Development Tribunal – Decision Notice

Appeal Number: 51-17

Site Address: 50 Crescent Road, Eumundi, Qld 4562, Lot 1 RP221269 — the subject site

Appeal under section 229 of *Planning Act 2016* (PA) against the Decision Notice of the Assessment Manager Sunshine Coast Regional Council to refuse a development application for the construction of a Class 10a shed as it did not meet and could not be conditioned to meet the following:

SITE PLAN

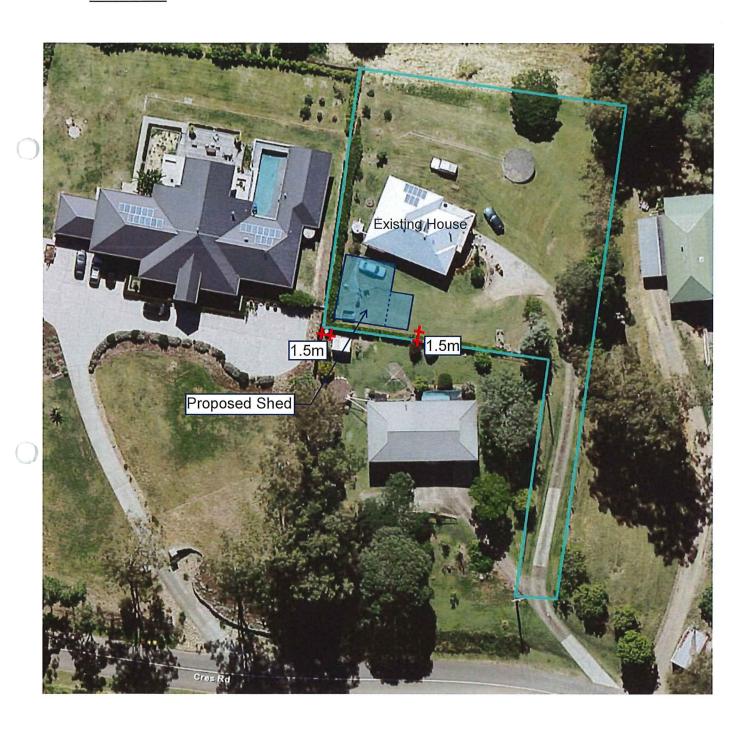
- The proposed Class 10a shed must be sited and built in accordance with the following drawings:
 - Fertile Soil Pty Ltd, Survey Plan, Site Plan, Plan Number DE18007-1, dated 15/1/2018;
 - Southern Cross Sheds, Site Plan, Drawing Number 51-17, Dated 31/1/2018, Sheet 1 of 2 (see Attachment 1); and
 - Southern Cross Sheds, Elevation Views and Plan View, Drawing Number 51-17, Dated 31/1/2018, Sheet 2 of 2 (see Attachment 2).
- The maximum roof pitch for the shed must not exceed 22.5°;
- The finished roof cladding, external wall cladding and external finishes of the shed must not be of a highly reflective colour i.e. white, silver, zincalume, etc. so as to limit the reflection of light towards the adjoining neighbouring properties; and
- The Applicant shall, prior to any building work commencing onsite, apply for and gain, a Development Approval for Building Work.

Likewise, it is the opinion of the Tribunal that the proposed shed needs to be reduced in height in order to achieve the Performance Outcomes of P2 of QDC MP1.2, given its close proximity to the adjoining allotment boundaries.

- The pitched changed to 22.5 ⁰ in order to further reduce the overall height of the building, the following; and
 - The shed to be clad in a non-reflective colorbond of a colour sympathetic to the existing dwelling.
